Title Main Board			
Size: B	Number: 2	Revision: 0.00	
Date: 9/12/2011	Time: 1:50:34 PM	Sheet 2 of 2

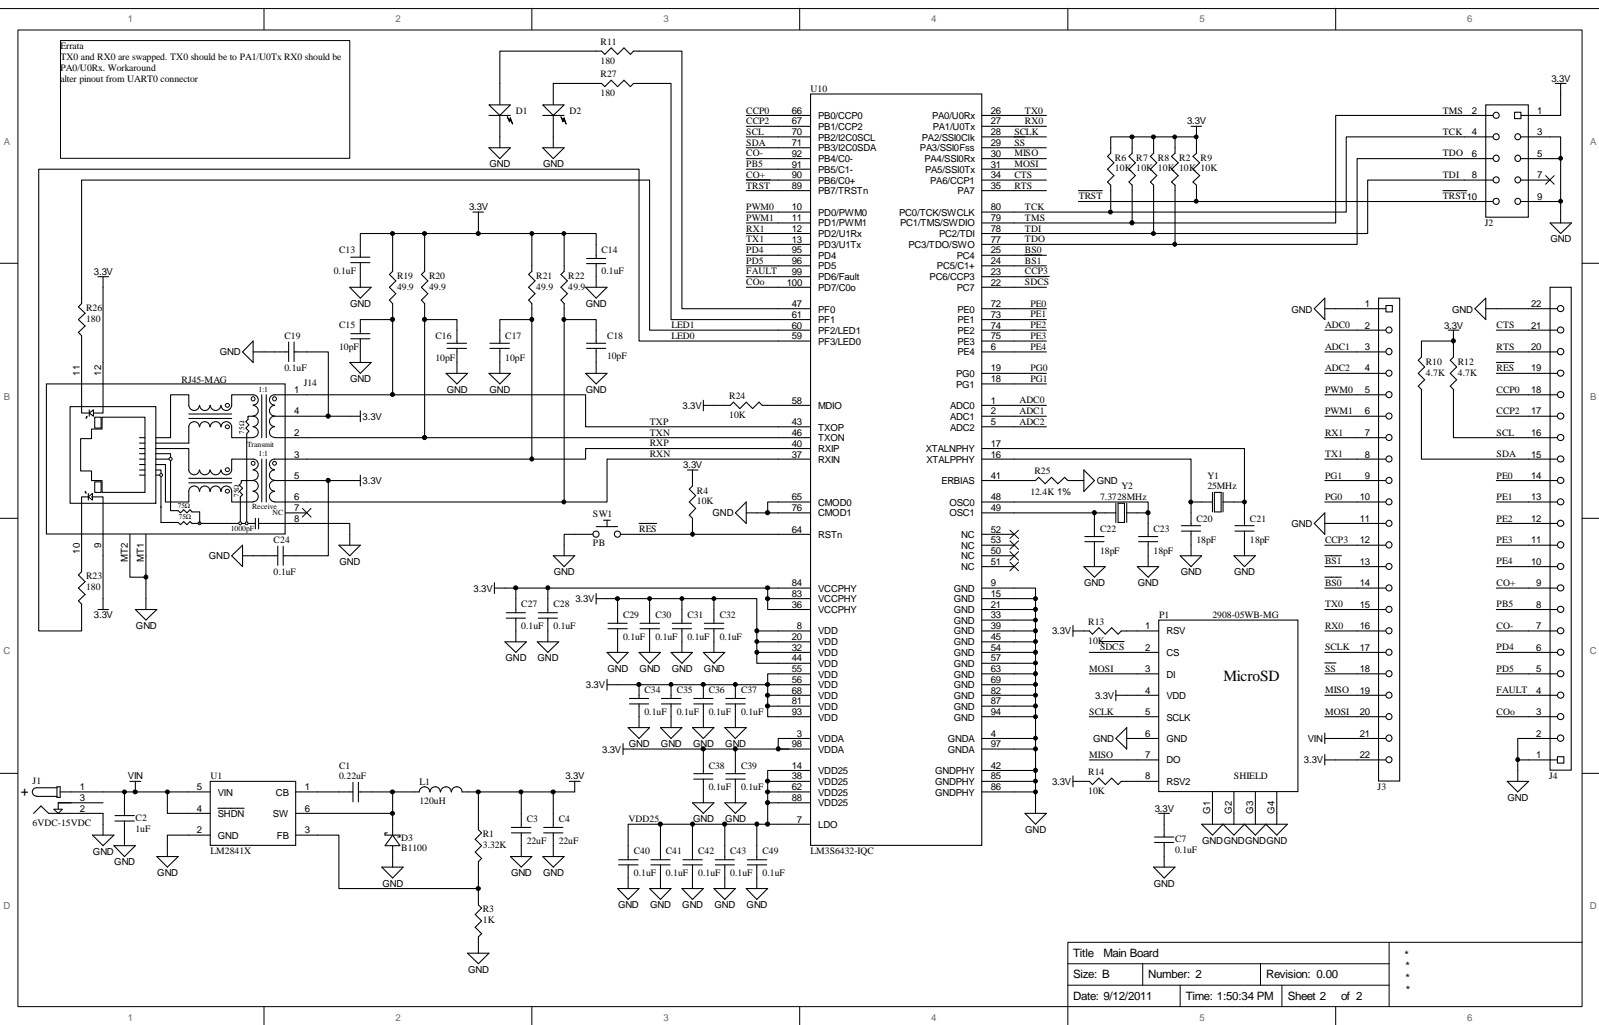
Errata
TX0 and RX0 are swapped. TX0 should be to PA1U0Tx RX0 should be PA1U0Rx. Workaround after pinout from UART0 connector
